2293 - KUM AND GO - PARKER, CO
NEC OF BAYOU GULCH RD AND PINERY PKWY

C2
2 OF 10

SITE PLAN
2293 - KUM AND GO - PARKER, CO
 NEC OF BAYOU GULCH RD AND PINERY PKWY
GRADING PLAN

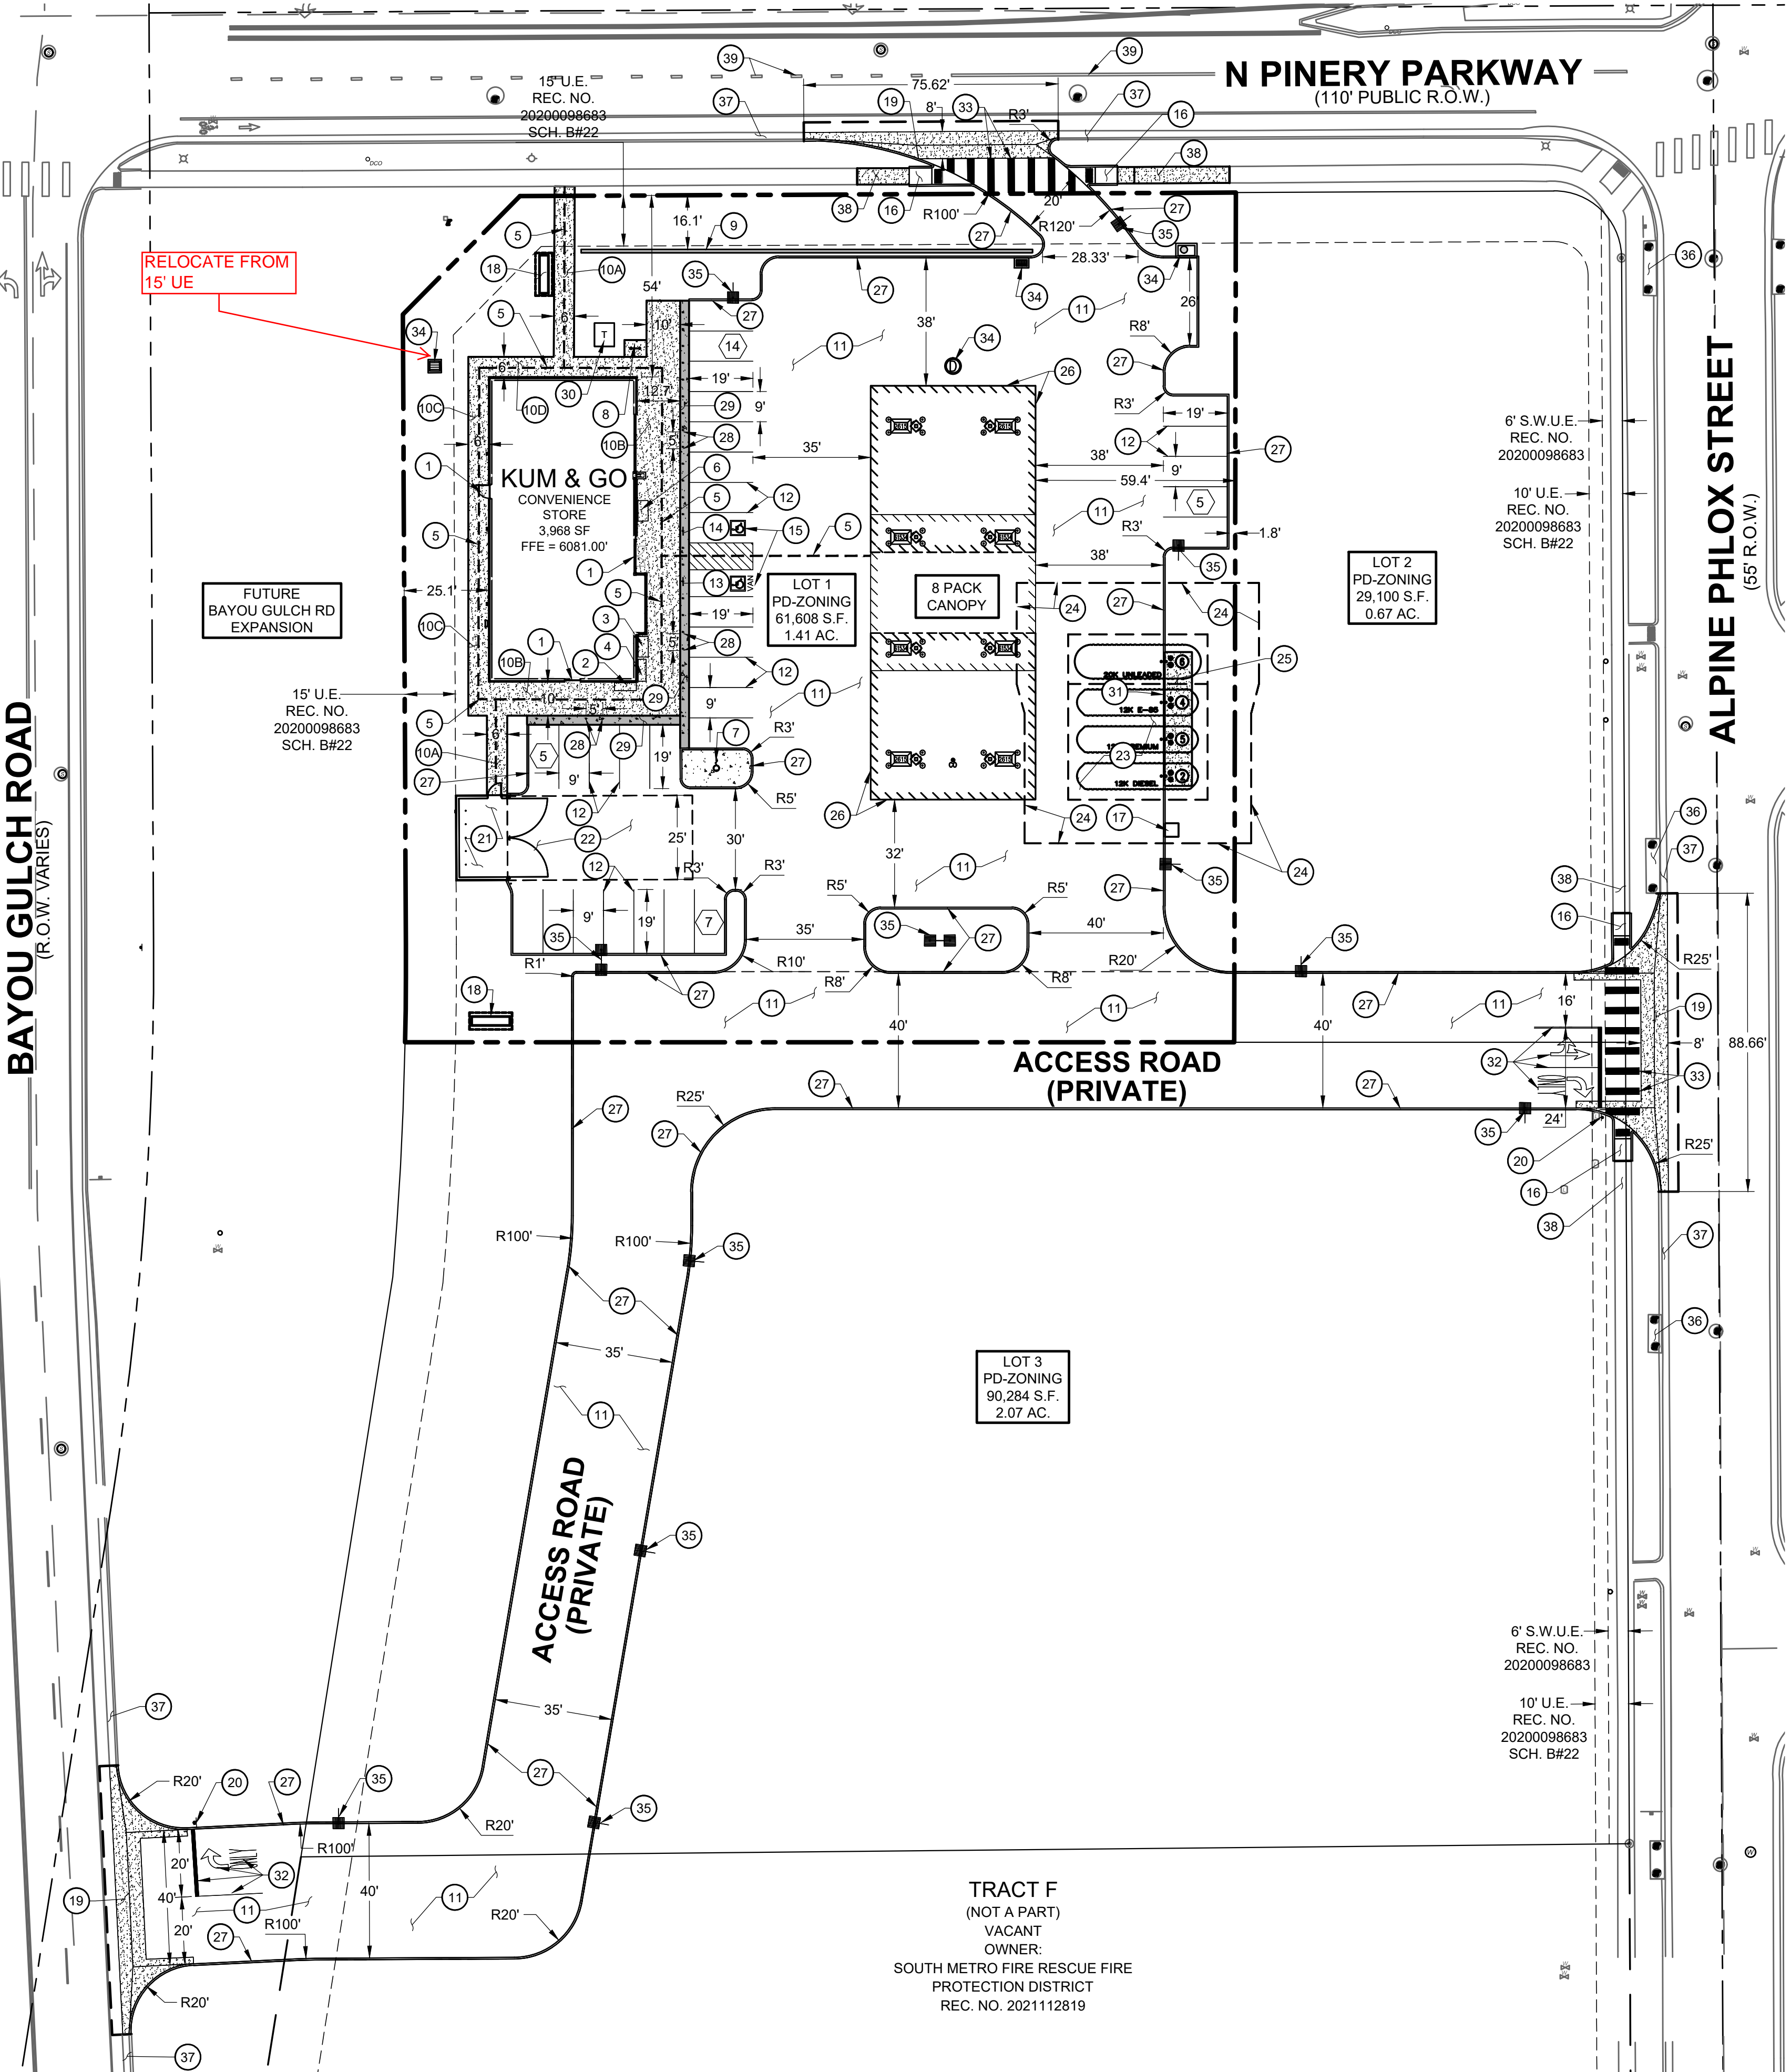
ADD REQUIRED UE FROM PLAT MARKUP
